Re: Watson Cogeneration Steam and Electric Reliability Project
Application for Certification 09-AFC-1

**SUPPLEMENT TO
RESPONSES TO QUESTIONS FROM THE
JANUARY 20, 2010 ISSUES RESOLUTION WORKSHOP
for Watson Cogeneration Steam and Electric Reliability Project**

**Supplement to Responses to Questions from the January 20, 2010 Issues
Resolution Workshop**

AFC Figure 5.5-1 Water Balance Flow Diagram

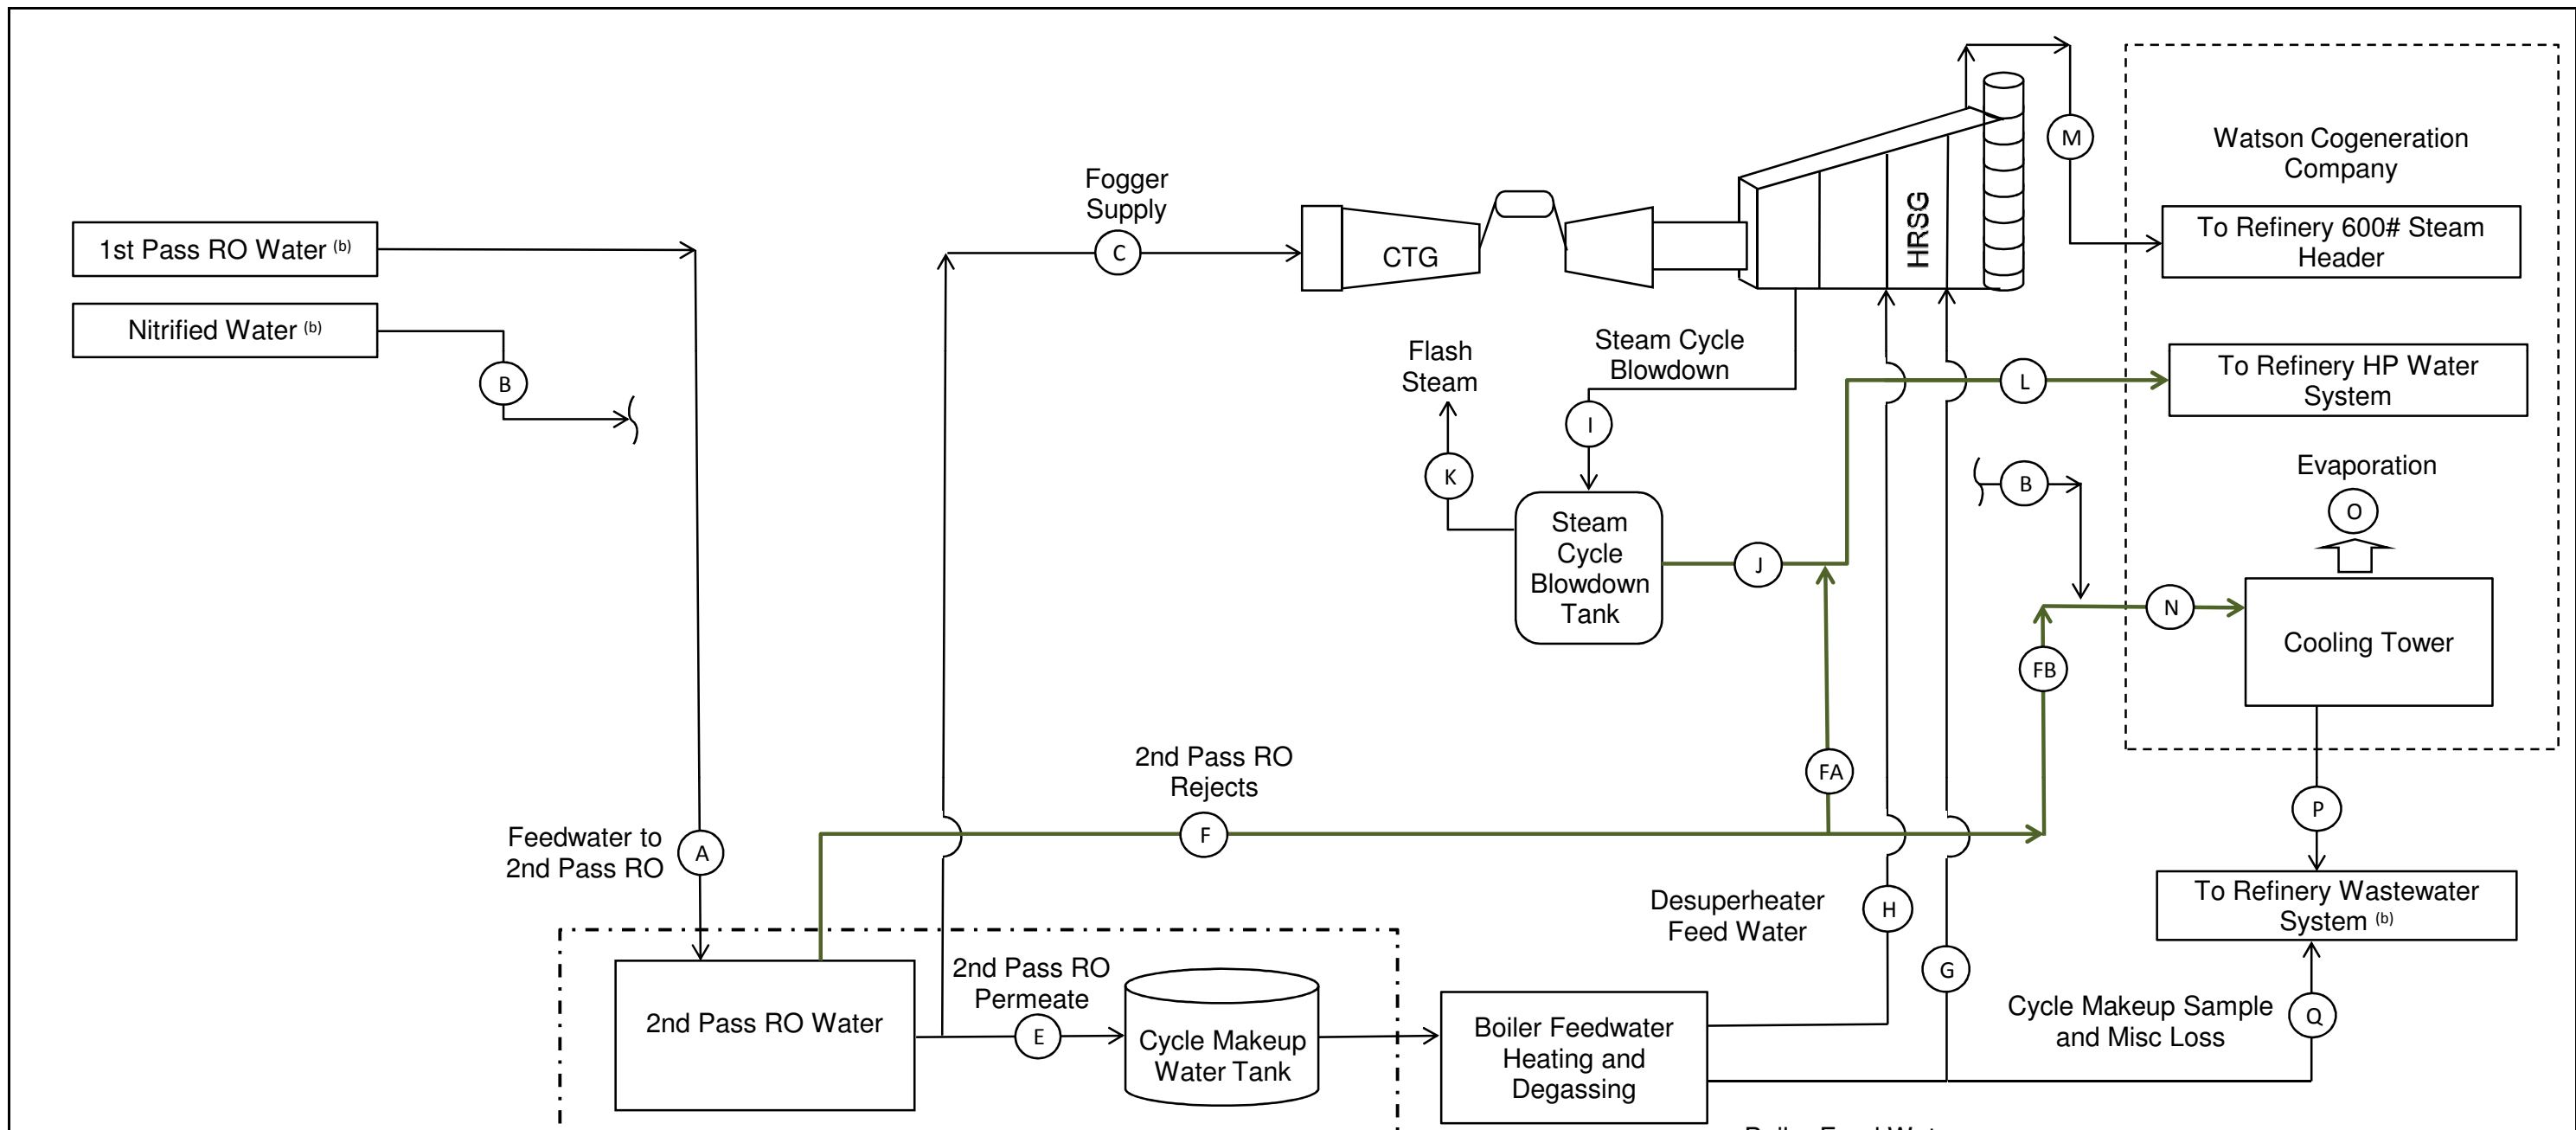
2. Please propose a Condition of Certification to monitor the water exiting the Project and to provide a minimum percentage of water to the BP Refinery based on the total water coming into the Project

Subsequent to further discussions with the California Energy Commission (CEC) technical staff, Watson proposes the following revision to the Condition of Certification that was provided in the February 2010 *Responses to Questions from the January 20, 2010 Issues Resolution Workshop*:

Prior to commercial operation, the Project owner shall install and maintain metering devices as part of the Project water supply and distribution system, to monitor and record in gallons per month the total volumes of water supplied to the Project via lines C, E, and F of the attached AFC Figure 5.5-1, Water Balance Flow Diagram, and the volumes of water supplied by the Fifth Train to Watson Cogeneration Company's steam header via line M and high-pressure water system via line L. The metering devices shall be operational for the life of the Project. The Project owner shall attempt in good faith to ensure that no less than 86 percent of the total volume of water supplied to the Fifth Train shall be delivered to the Watson Cogeneration Company's steam header and/or high-pressure water system on an annual basis. This percentage is a voluntary, non-binding goal and the Project owner shall not be deemed out of compliance with this condition for failure to achieve this percentage, provided the Project owner: 1) installs and maintains the metering devices described above; 2) attempts in good faith to achieve the non-binding percentage goal described above; and 3) provides the information set forth in the verification below.

Verification: At least 30 days prior to commercial operation of the Project, the Project owner shall submit documentation to the California Energy Commission (CEC) Compliance Project Manager (CPM) that metering devices for the Project have been installed on lines C, E, F, L, and M and are operational. The Project owner shall prepare an annual water usage summary giving the monthly total and annual total of water delivered to the Fifth Train via lines C, E, F, and from the Fifth Train to the Watson Cogeneration Company's steam header and/or high-pressure water system. The summary shall also state the annual percentage of the volume of water supplied to the Fifth Train that is delivered to the Watson Cogeneration Company's steam header and/or high-pressure water system. The percentage shall be computed as $(L+M)/(C+E+F)$. The annual summary shall be included in the Annual Compliance Report. To the extent that the reported percentage for any year falls below the 86 per cent goal, the Project owner shall include in the

summary the reasons for failing to achieve the goal and any steps that it has taken or intends to take to improve the percentage.
